Solicitation Addendum

Addendum No.:	2
Solicitation No.:	21-TA003586JH
Project No.:	6099860
Solicitation Title:	Lockwood Ridge Road at Shopping Center Intersection Improvements
Addendum Date:	February 11, 2021
Procurement Contact:	Jeb Hayter Procurement Agent

BID ATTACHMENT 5 – GENERATOR CABINET AND TRAFFIC INFRASTRUCTURE DESIGN GUIDE.

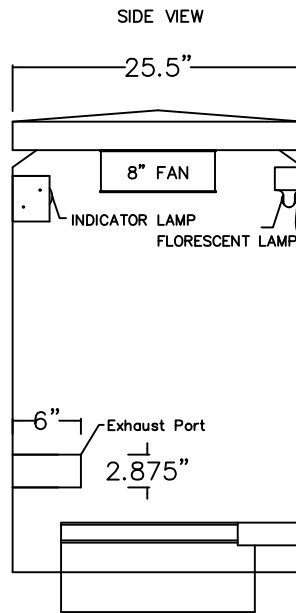
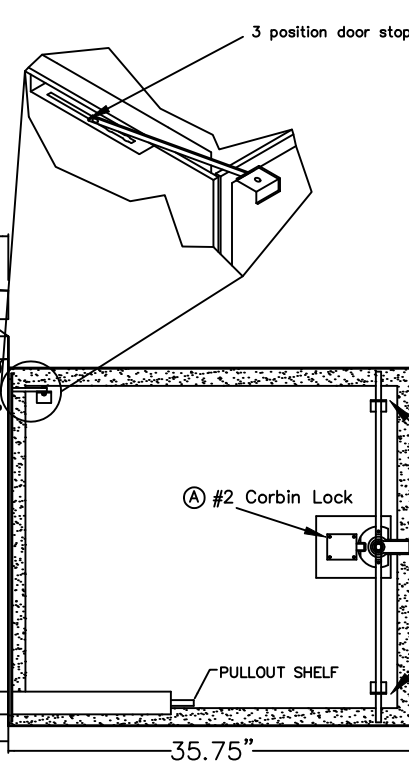
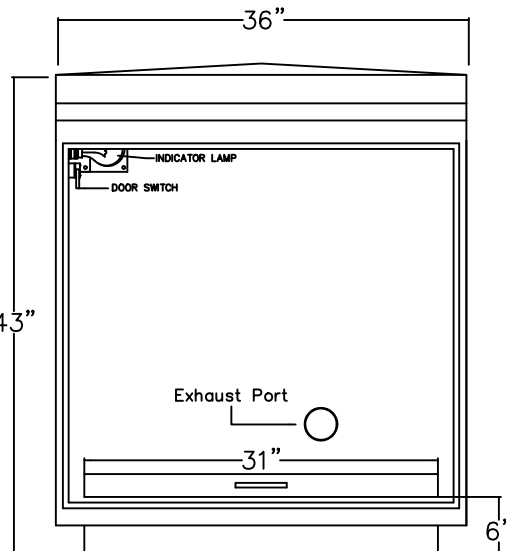
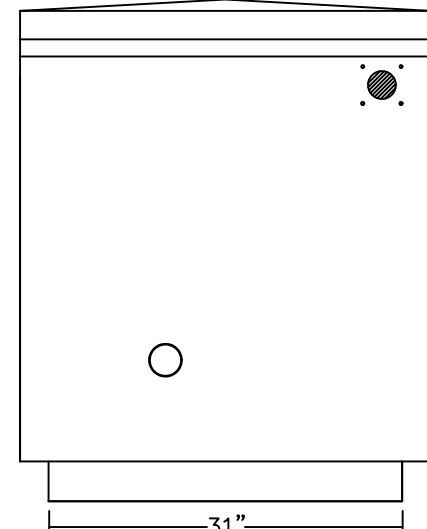
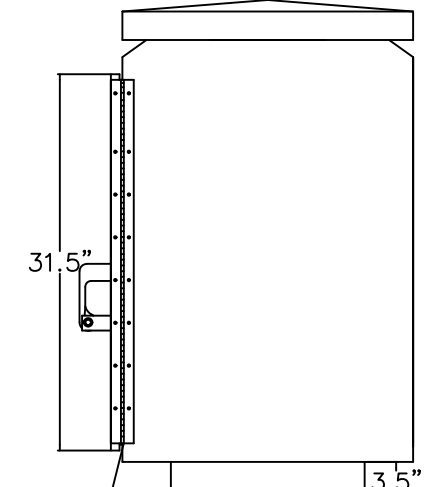
- Q1. Please confirm the Contractor is to furnish the generator under pay item 639-4-6. Or is the County supplying the generator?**
- R1. The project / contractor will need to furnish and install the generator cabinet foundation and cabinet housing, not the generator.
- Q2. Please provide details on the required generator and housing: Housing material type (steel aluminum, concrete, etc.). Dimensions on the housing and on the concrete pad.**
- R2. See Bid Attachment 5- Generator Cabinet and Traffic Infrastructure Design Guide

R3. This is just the cabinet foundation and cabinet housing, No generator.
